Title - Sujet Greenstone Building Fit-Up	
Solicitation No. - N° de l'invitation EW038-172580/A	Amendment No. - N° modif. 005
Client Reference No. - N° de référence du client PWGSC EW038-172580	Date 2017-02-17
GETS Reference No. - N° de référence de SEAG PW-\$PWU-107-10995	
File No. - N° de dossier PWU-6-39304 (107)	CCC No./N° CCC - FMS No./N° VME
Solicitation Closes - L'invitation prend fin at - à 02:00 PM on - le 2017-02-21	Time Zone Fuseau horaire Mountain Standard Time MST
F.O.B. - F.A.B. Plant-Usine: <input type="checkbox"/> Destination: <input checked="" type="checkbox"/> Other-Autre: <input type="checkbox"/>	
Address Enquiries to: - Adresser toutes questions à: Anthony, Mary	Buyer Id - Id de l'acheteur pwu107
Telephone No. - N° de téléphone (780) 237-7582 ()	FAX No. - N° de FAX (780) 497-3510
Destination - of Goods, Services, and Construction: Destination - des biens, services et construction:

Electrical Addendum E-02

Project Name: PWGSC 3 rd Floor Renovation Greenstone Building		
Client: PSAV Architects Ltd.		
Project No.: 35004.00		Date: February 15, 2017
Distribution:		
Gene Drouin	PSAV Architects Ltd	gene@psav.ca

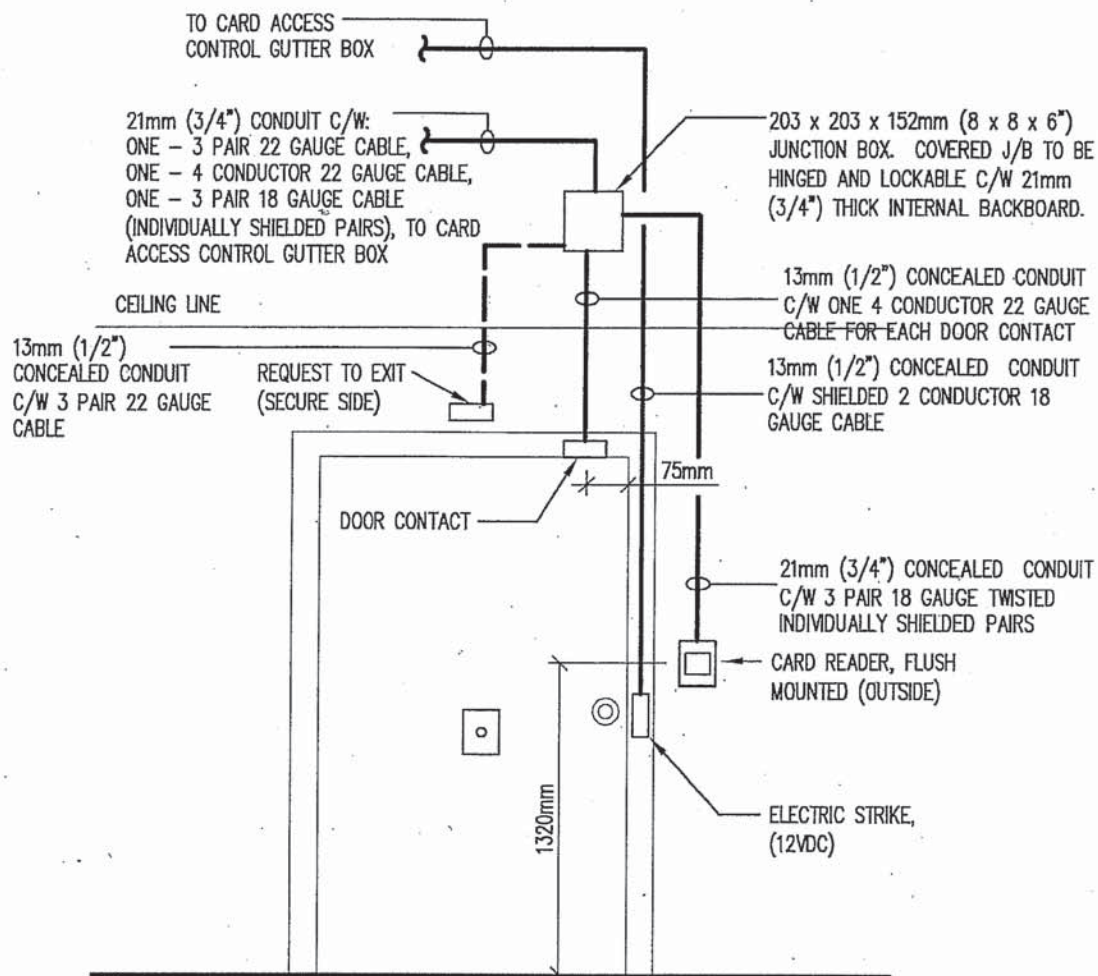
- .2 RFI Question: In terms of Security, the spec says to match existing wiring for devices. Little information is given for what is existing. A door detail of where the security devices are located, sizes of conduit needed and types of wire within them would be very helpful.

Response: The existing system is a Lenel Card Access system. Confirm door details onsite with system requirements. Assume the below elevation for pricing.
